**STATE OF MARYLAND
CHESAPEAKE BAY CRITICAL AREA COMMISSION**

**RE: Kirtland Subdivision, SUB 982
DC 224-01**

Thank you for providing information on the referenced project. The applicant is proposing an intrafamily transfer based on our discussion when we met on June 8, 2001. I have reviewed the subdivision plat and your letter to Mr. Callahan dated August 31, 2001, and I have the following comments:

LINE REVISION
LOTS 1-3
MARY RYAN KIRTLAND
8th Election District
DORCHESTER COUNTY, MD.

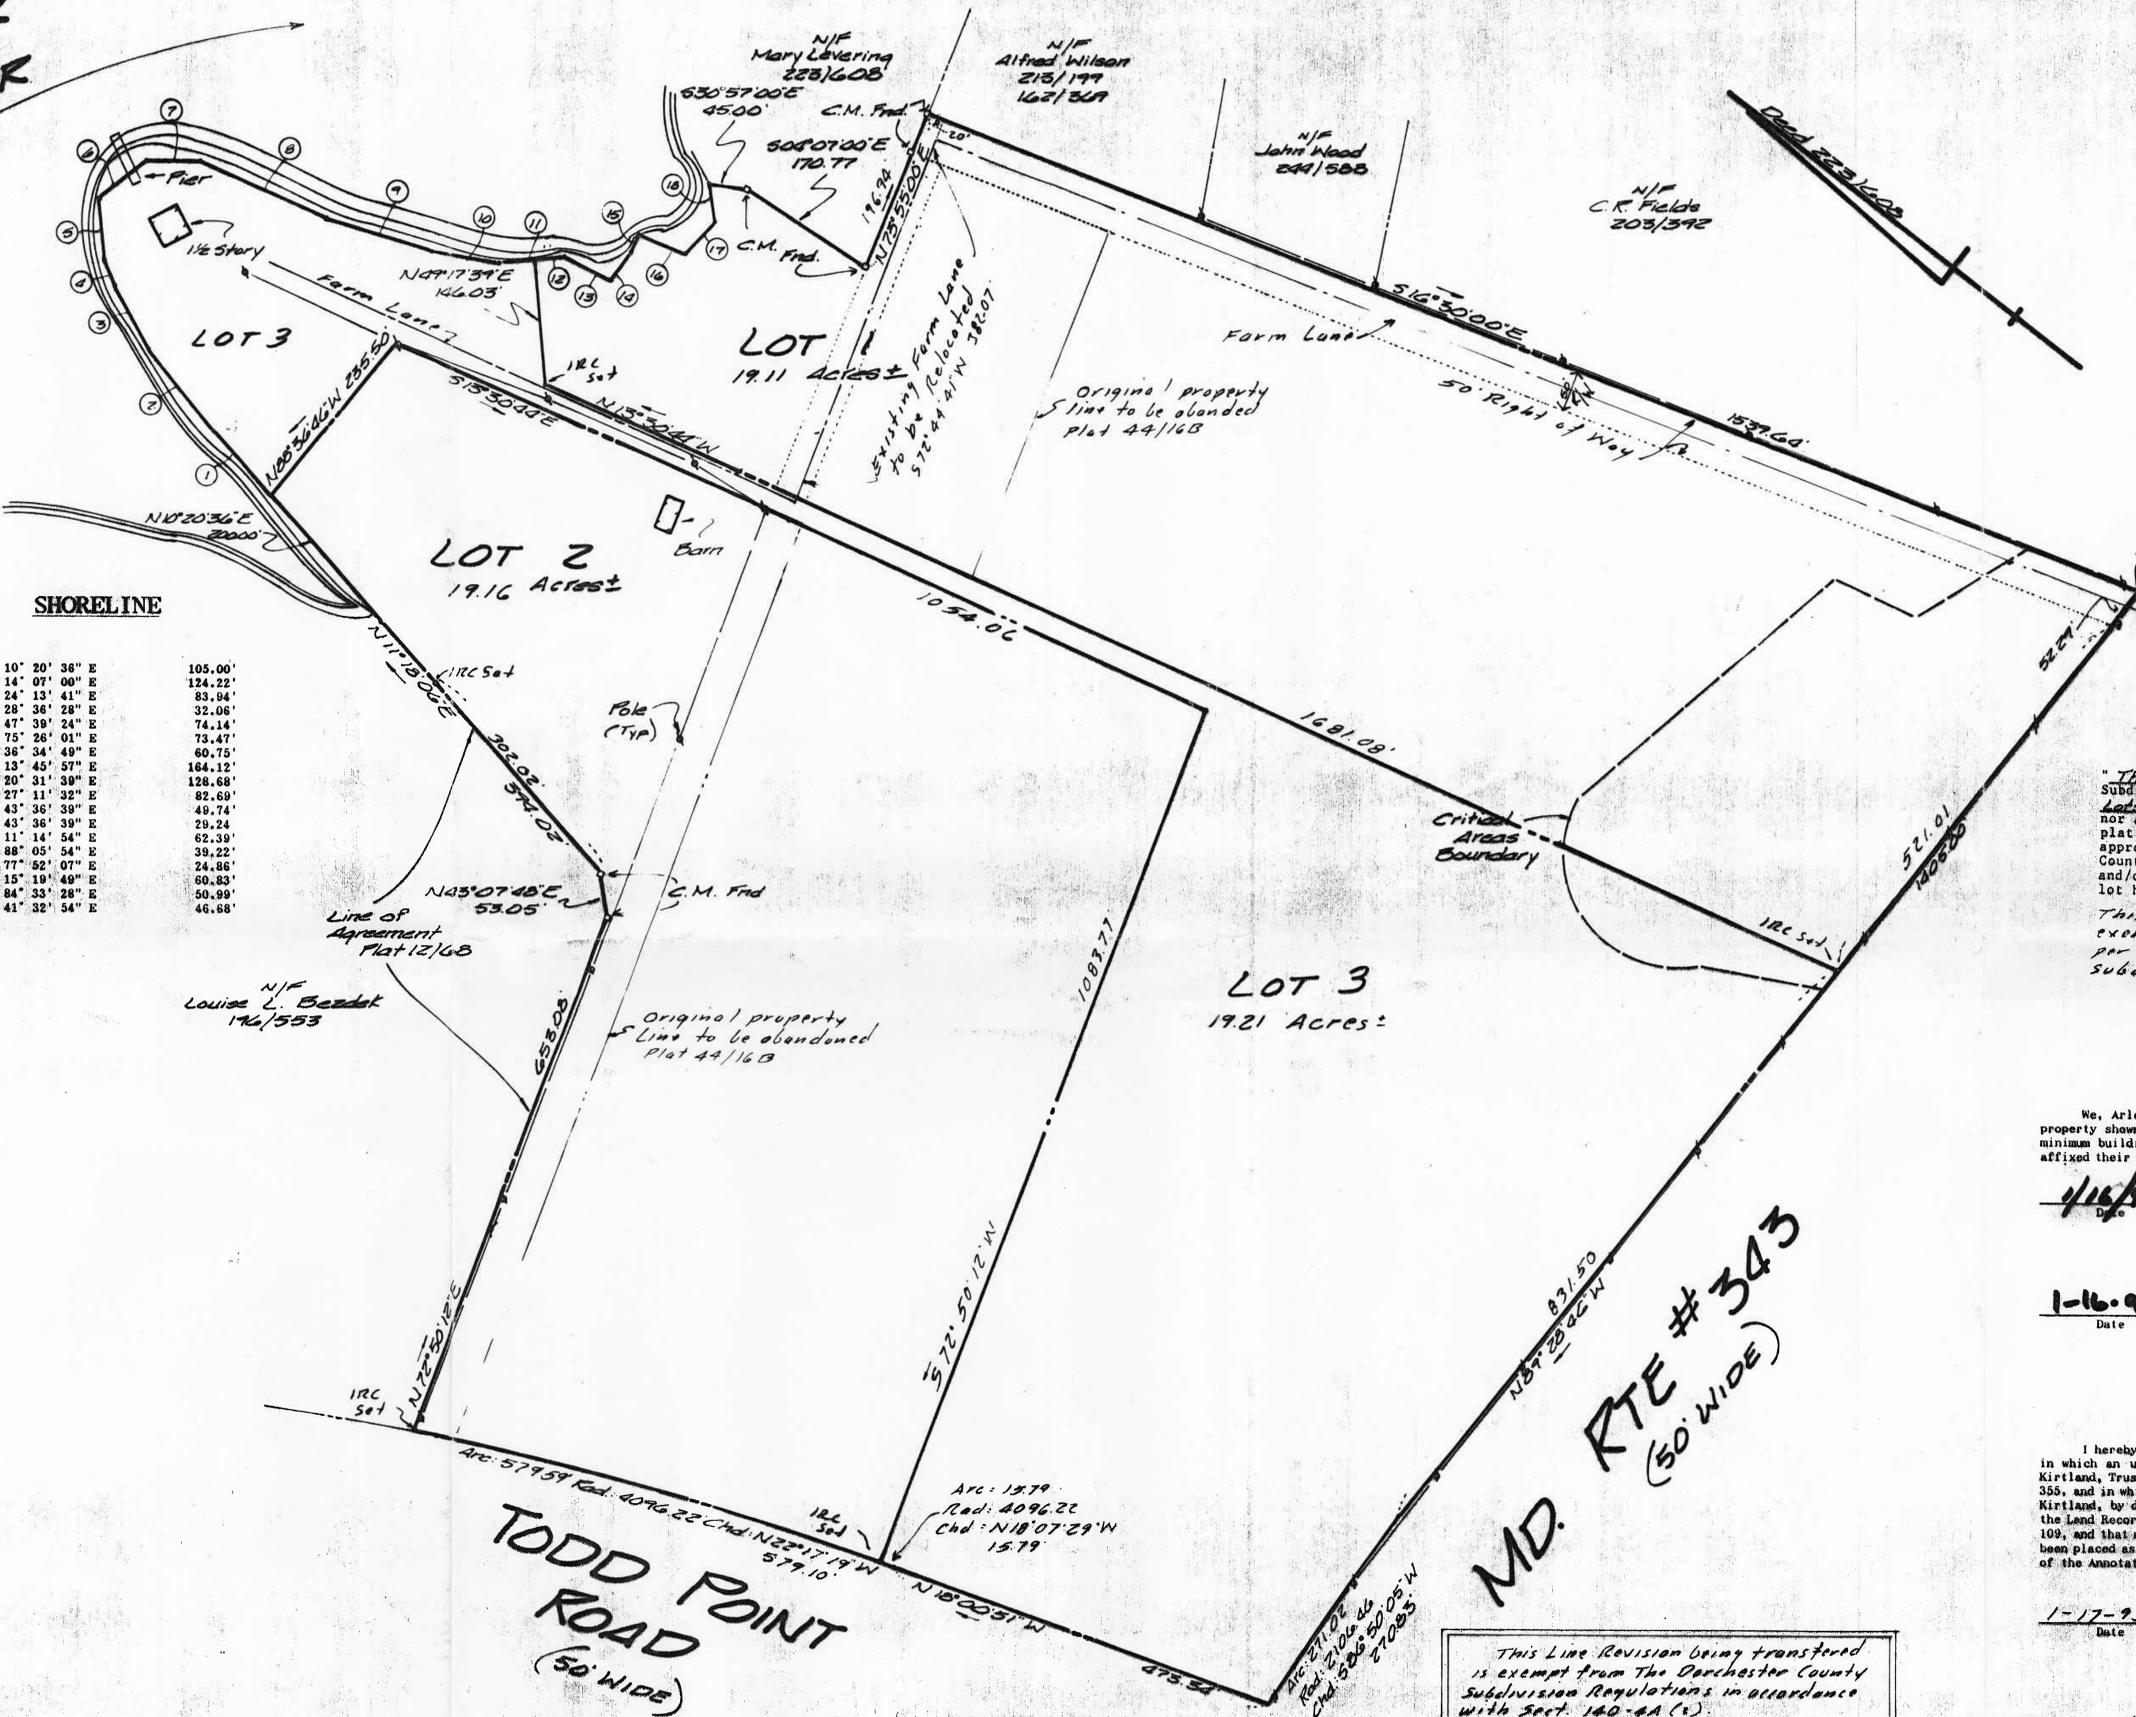
3. The subdivision plat should show the Critical Area boundary, Critical Area designation, and the Critical Area acreage and total acreage of each lot.

5. The 100-foot Buffer must be shown on the subdivision plat. Plat notes should indicate that new development activities and land disturbance are prohibited in the Buffer. Plat notes should also indicate that clearing of existing natural vegetation is not allowed.

6. The plat does not indicate that the 100-foot Buffer will be fully established in natural vegetation. In accordance with §27.01.09.01.C(6) of COMAR, when agricultural use of the property ceases and the land is converted to other uses (i.e. residential development), the 100-foot Buffer must be established. The applicant must indicate how this requirement will be addressed.

7. Forest cover must be shown on each lot. If total forest cover for the subdivision is less than 15%, afforestation will be required.
8. The plat should include a note stating that impervious surface area is limited to 15% of each lot.

9. The plat does not include topography or any information about slopes greater than 15%.
10. The plat does not include information about perennial and intermittent streams.
